Syracuse City Planning Commission Meeting April 2, 2019

4. Public Hearing – Request from Utah Land Surveying for a Subdivision Amendment called Cherry Village Subdivision No 1 Amended 1, approx. 0.49 acres located 2262 W 1825 S

7. Final Plat – Legend Pointe Subdivision Phase 1, located approx. 900 S 3695 W

Final Subdivision Plan Review

SHEET
1 OF 1

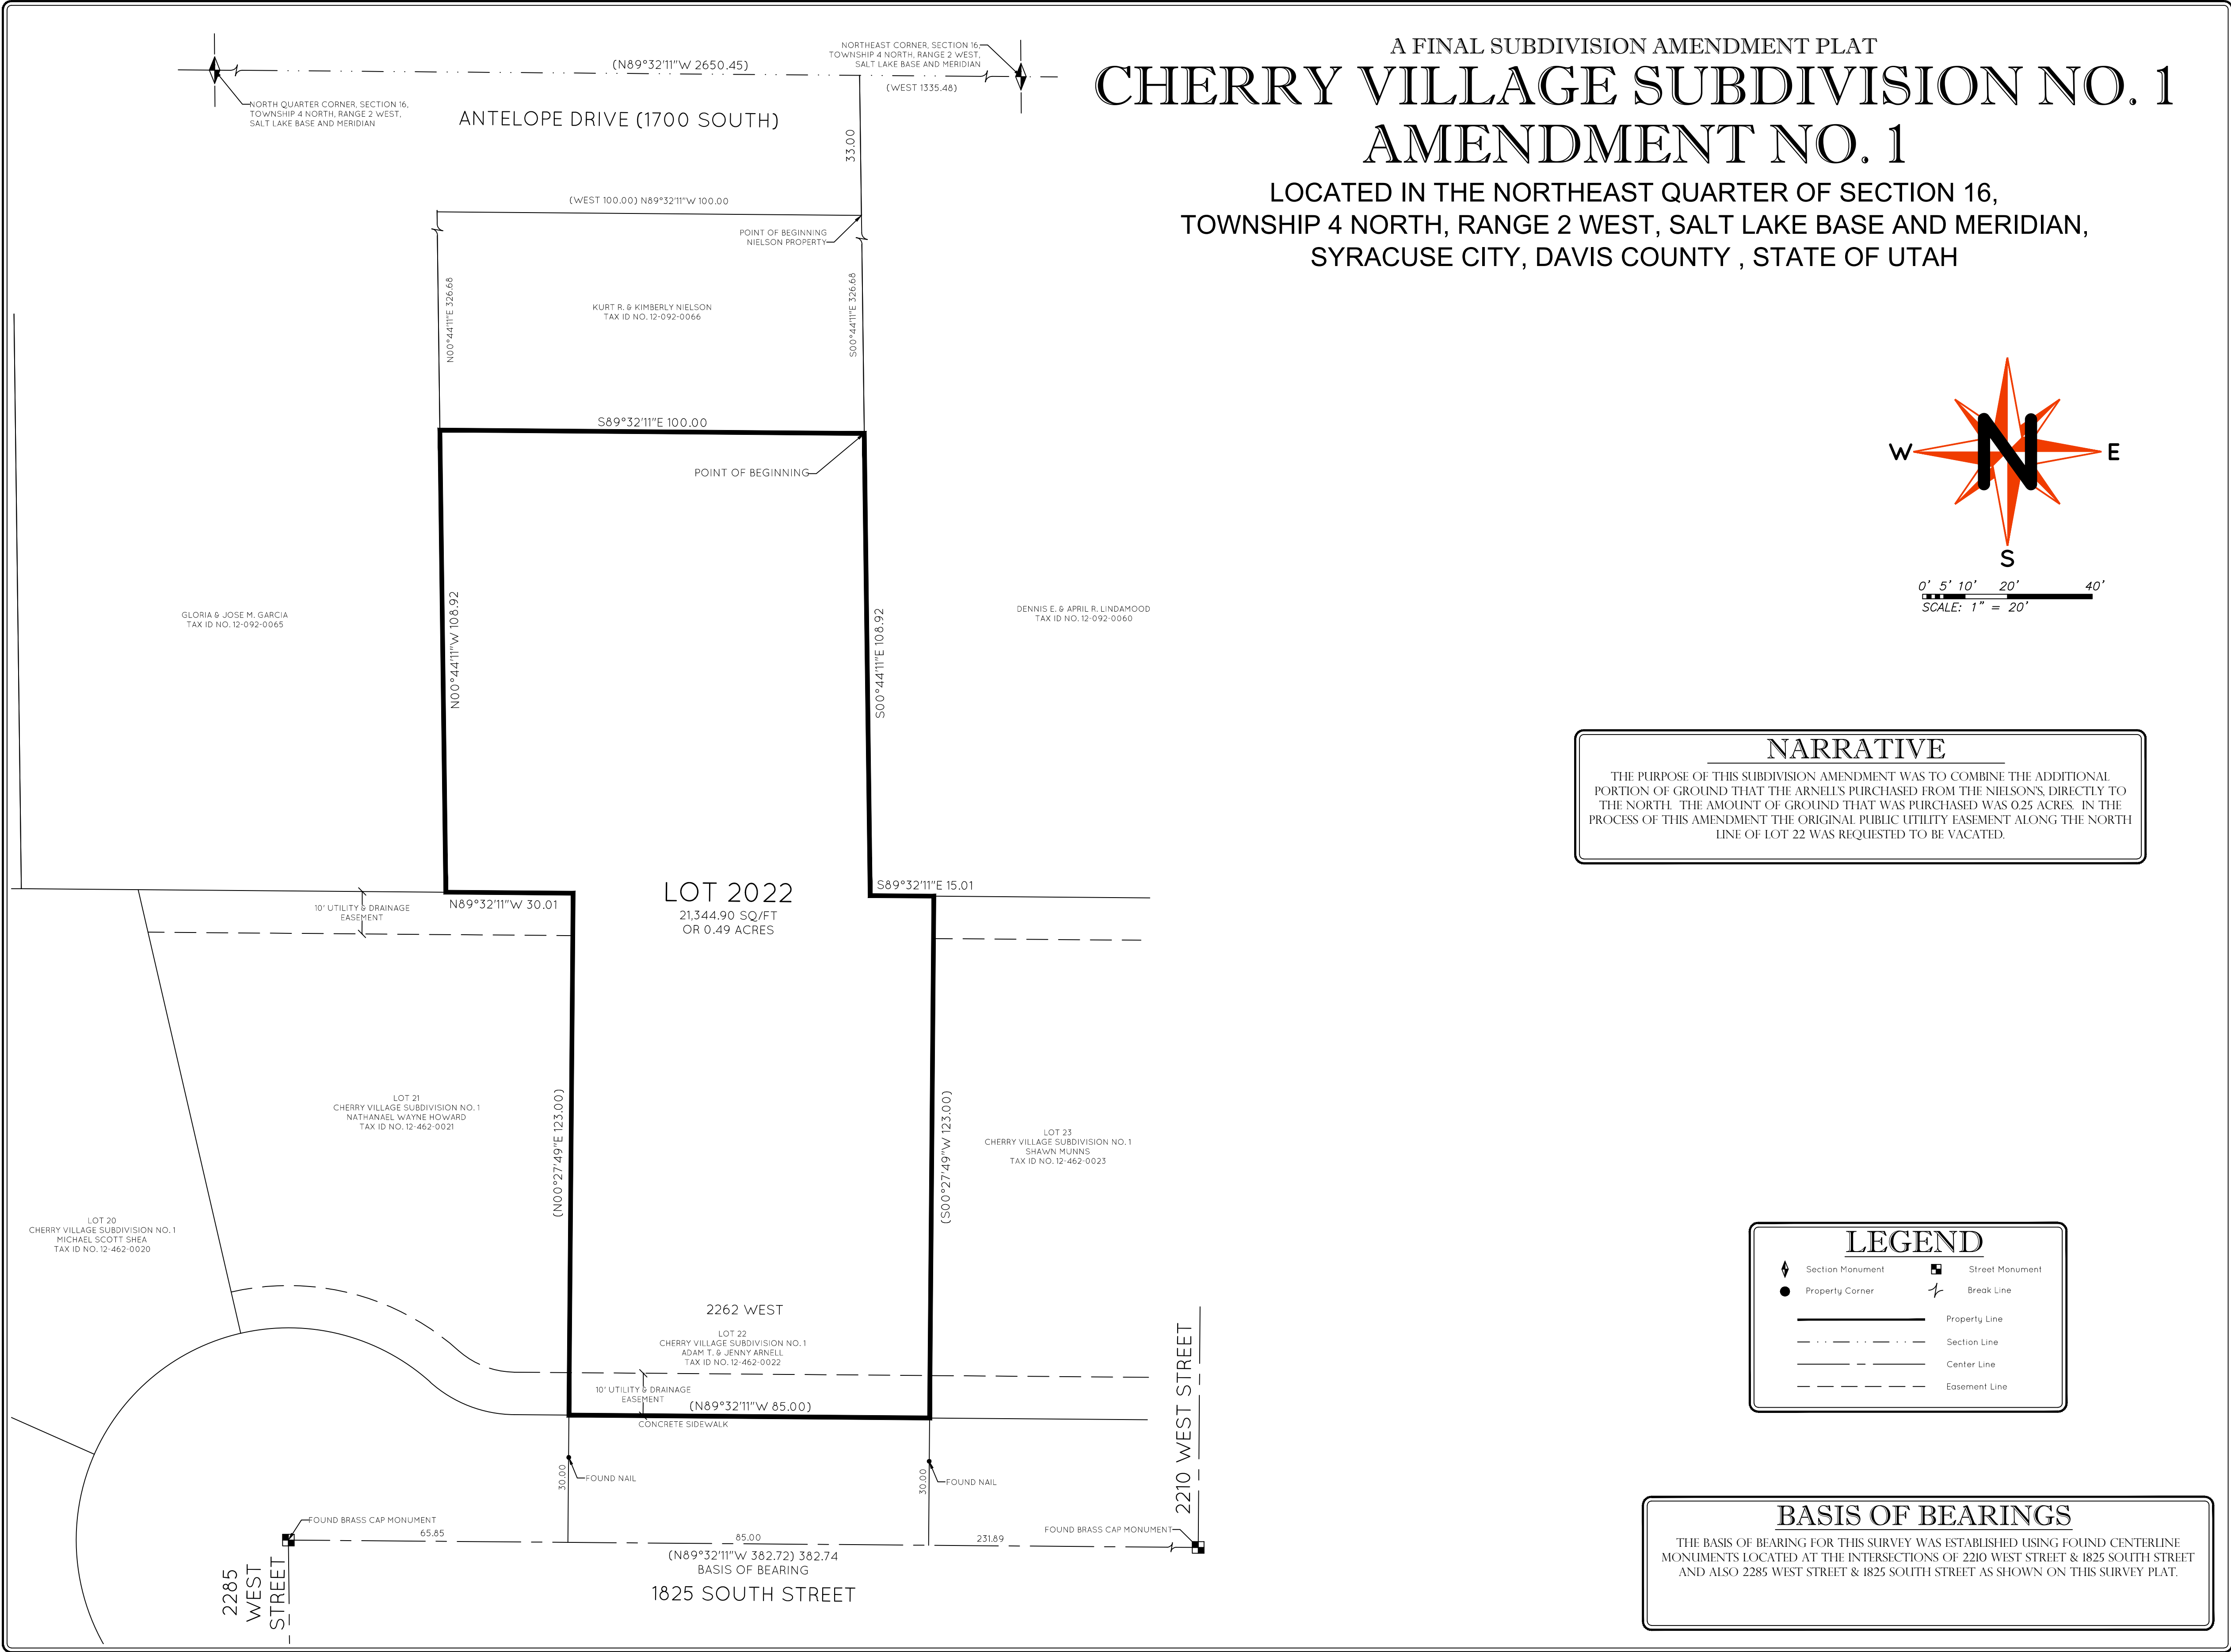
1. Add signature blocks for the utility companies.
2. Show all existing easements.

1. While the level of preliminary detail on the plat is appreciated, the plat should be drawn in final plat format with the following:
 - a. Owner's Dedication with the following language:
 - i. "warrant and defend and save the City harmless against any easements or other encumbrances on the dedicated streets which will interfere with the City's use, maintenance and operation of the streets."
 - b. The Planning Commission box should refer to the Planning Commission Chair, not the Planning Division Manager.
 - c. Public Utilities approval and acceptance of public utility easements.

SYRACUSE CITY PLANNING COMMISSION

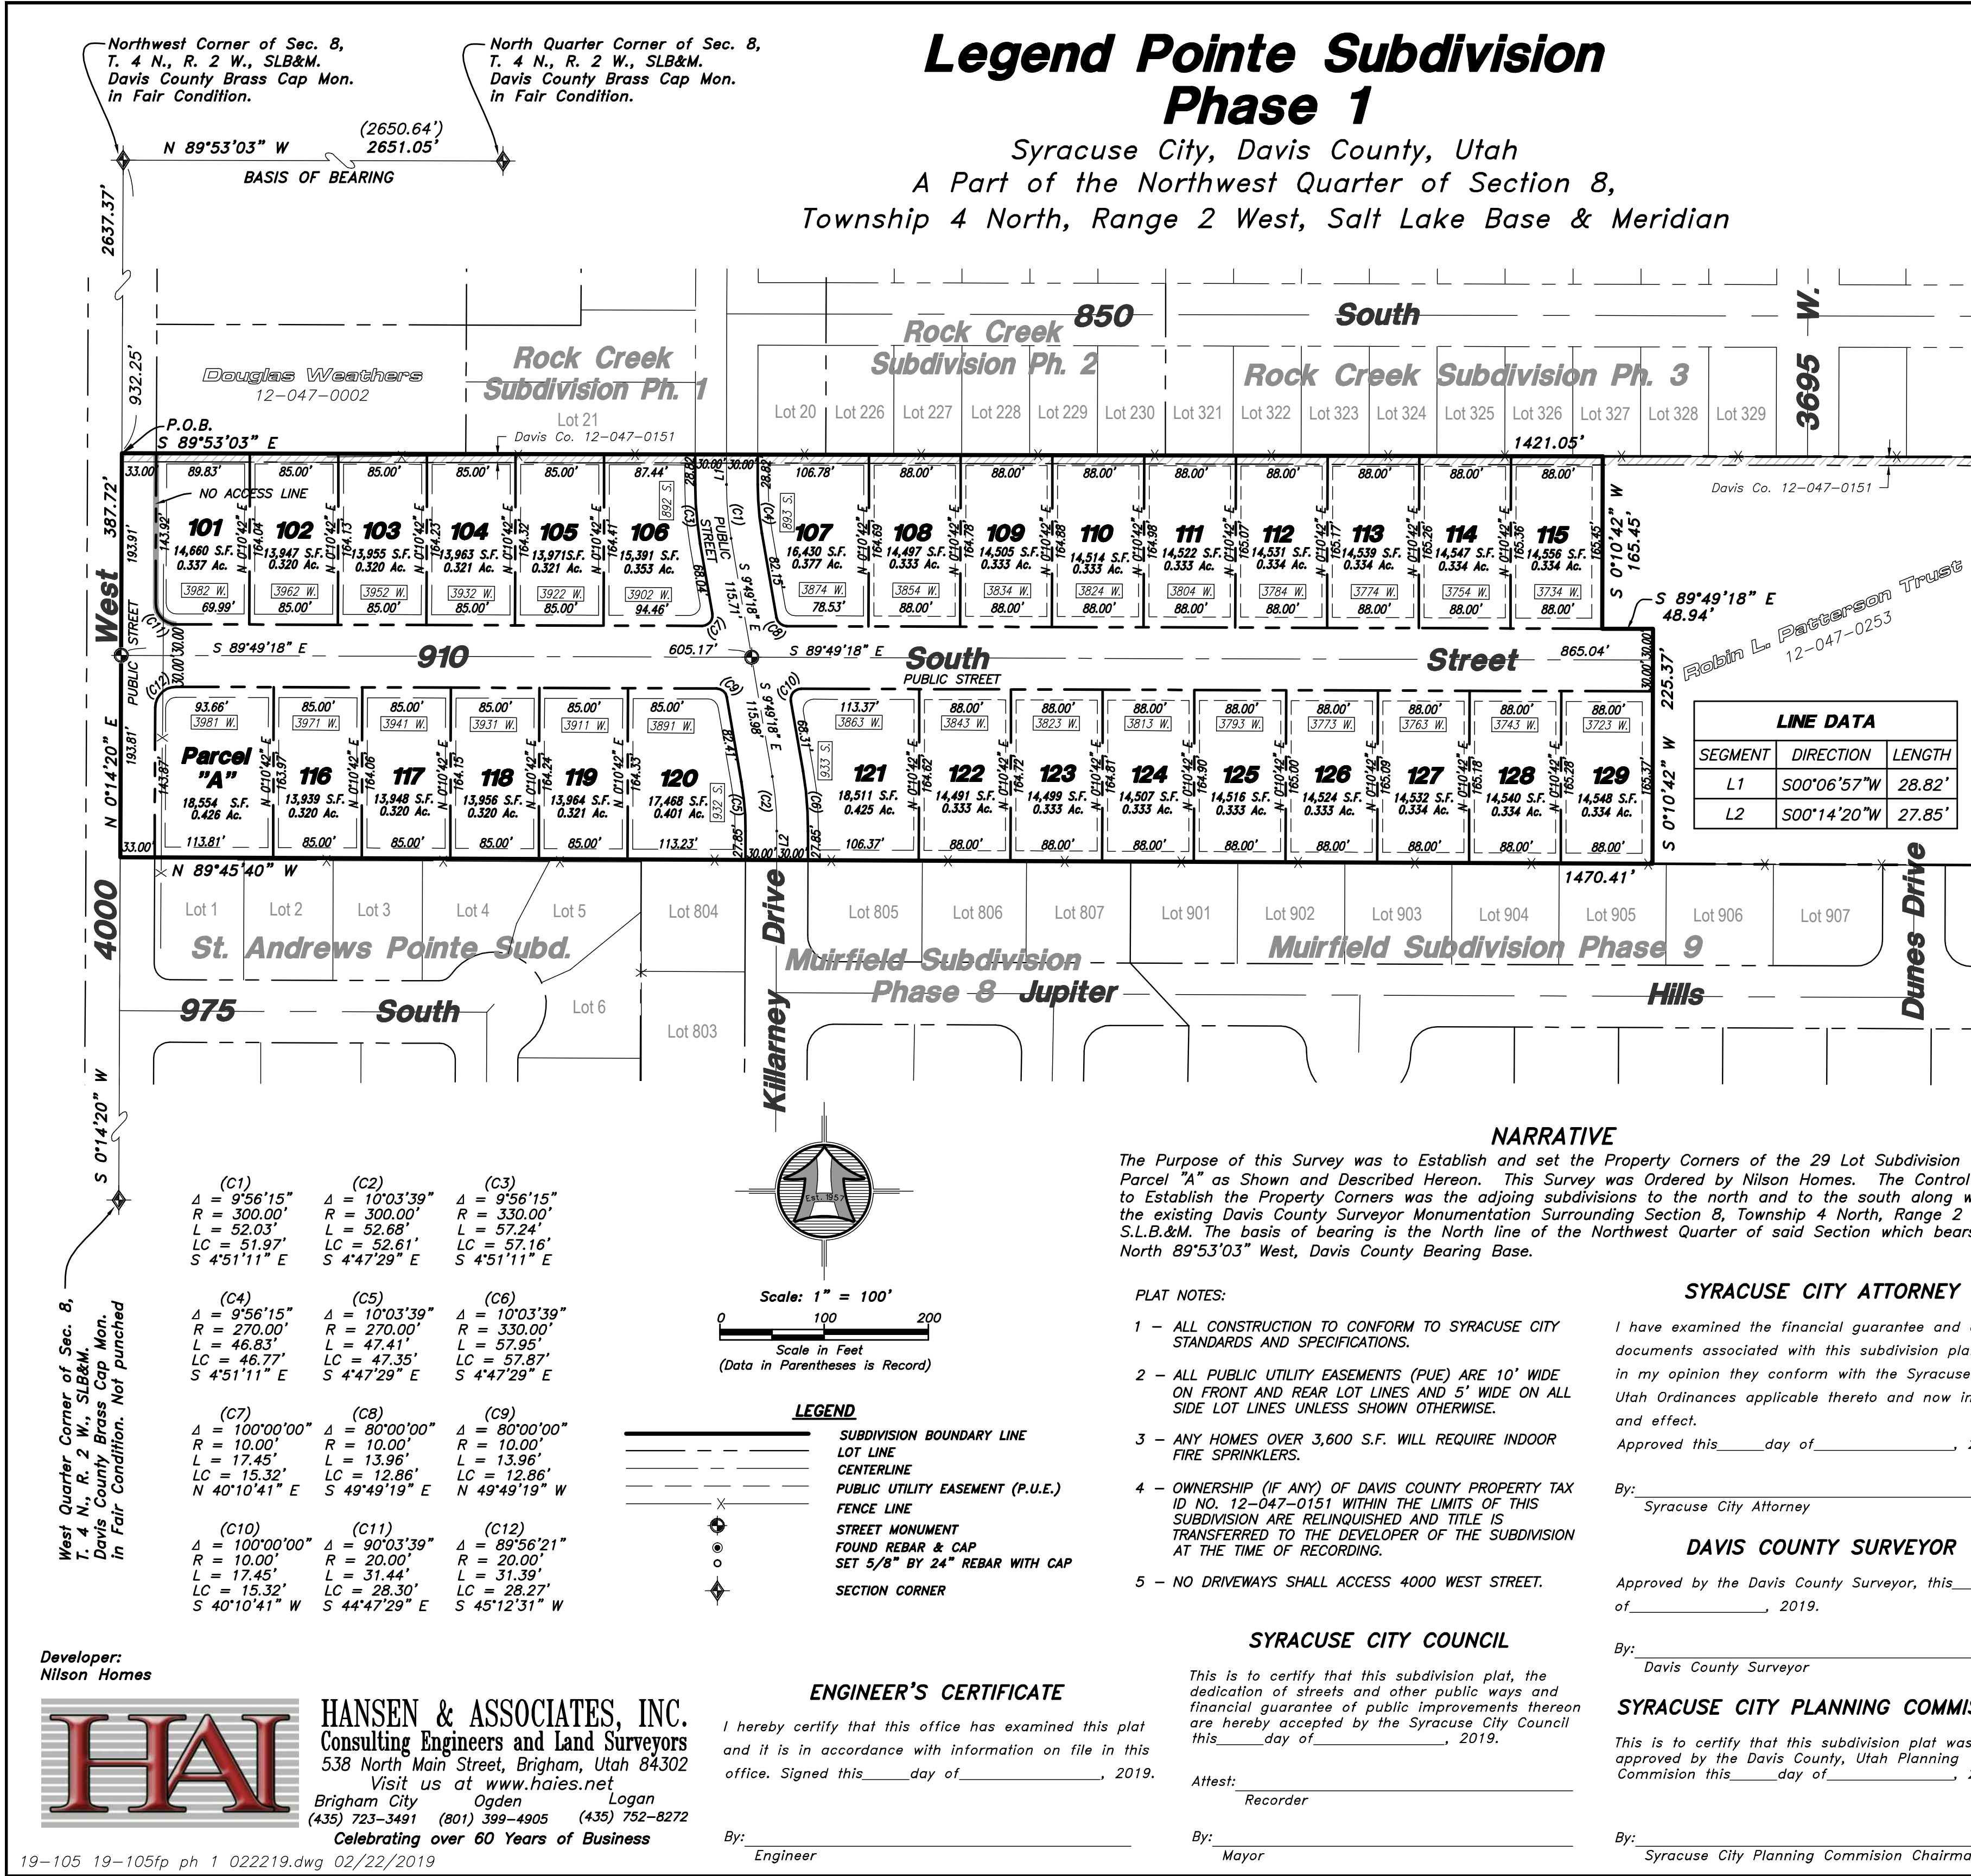
1. Remove the Davis County parcel along the north edge of the property.
2. Remove Plat note 4. The leftover Davis County Parcel will be rectified with the quit claim deed.
3. Show addressing in accordance with the attached addressing list. Corner lots on 4000 West are not fully addressed.
